An Amendment to the

Balboa Park Master Plan

Proposed Amendment for Plaza de Panama, Circulation, and a Parking Structure

April 5, 2012 Sixth Draft

EL PRADO WEST Figure 3

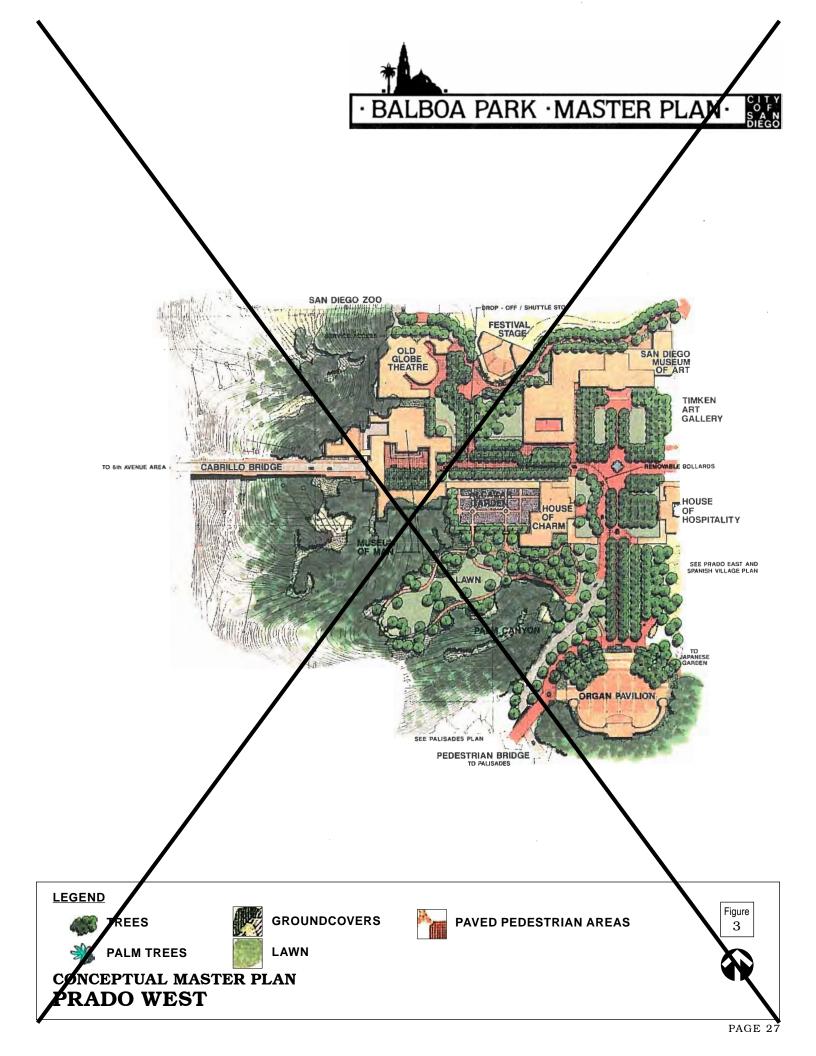
The Cabrillo Bridge will carry eastbound and westbound traffic. The Centennial Bridge (a by-pass bridge) will be constructed from the eastern end of the Cabrillo Bridge leading to the Alcazar parking lot, thereby eliminating the need for vehicles to travel through West El Prado, Plaza de Panama, and The Mall. The new Centennial Road will be constructed and lead from the Alcazar parking lot to the new parking structure and, ultimately, to Park Boulevard. only eastbound automobile traffic, freeing the westbound lane for the intrapark tram, inter-park shuttle, bicycles, and pedestrian use. The direction of travel couldbe reversed or two way traffic could be allowed if needed to facilitate traffic flow during certain times, such as after theater or during other special events.

Automobile parking <u>and vehicular traffic</u> will be eliminated from the Plaza de Panama which will become a pedestrian area. Enhanced pavement, plantings, sculptural and/or water features, and appropriate and attractive site furnishings will be provided.

THE PALISADES Figure 5

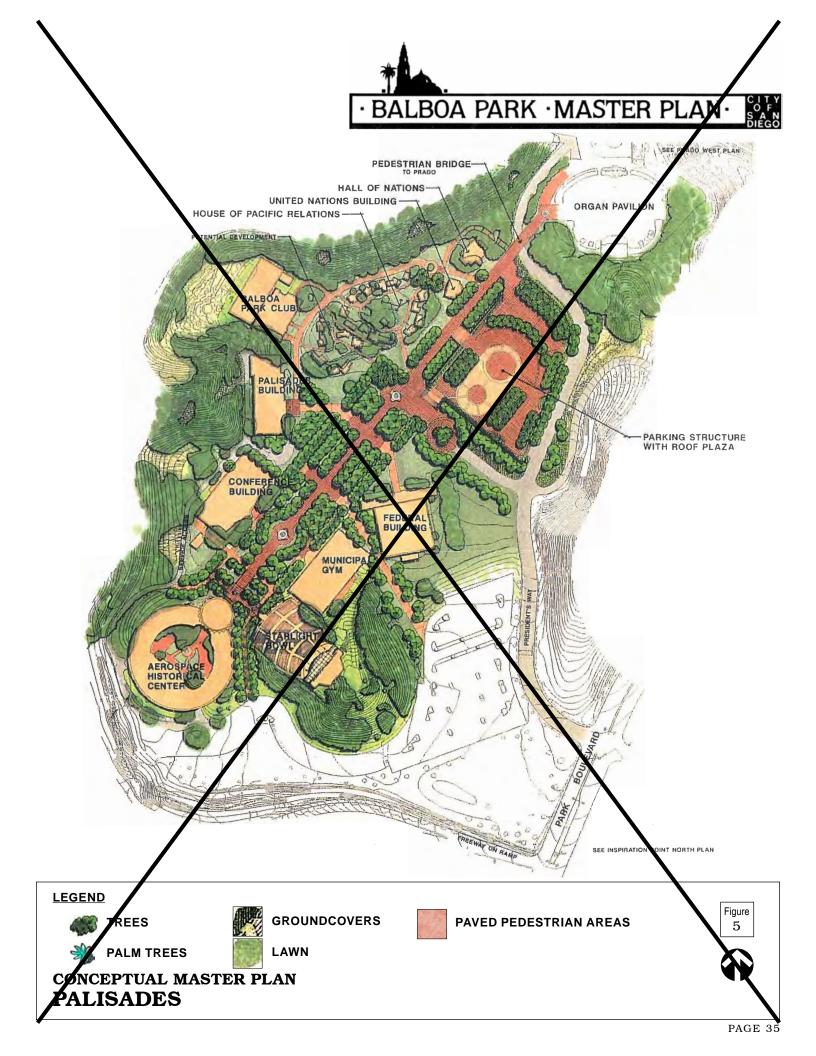
A parking structure will be developed on the Organ Pavilion parking lot. The top of the parking garage will function as an open space and pedestrian use area. Design of the facility will be subject of an architectural design competition to ensure the widest possible search for a quality design.

A pedestrian promenade will be created on the western side of the parking structure to create a strong pedestrian linkage with the Prado. Consideration should be given to realigning Presidents Way through the Organ Pavilion parking structure to further emphasize pedestrian uses along the promenade. Automobile access from the parking structure to the Prado Alcazar parking lot will pass under the promenade.

A drop-off and pick-up area will be created south of the parking structure on the Presidents Way alignment. This cul-de-sac may also be used as a shuttle stop.
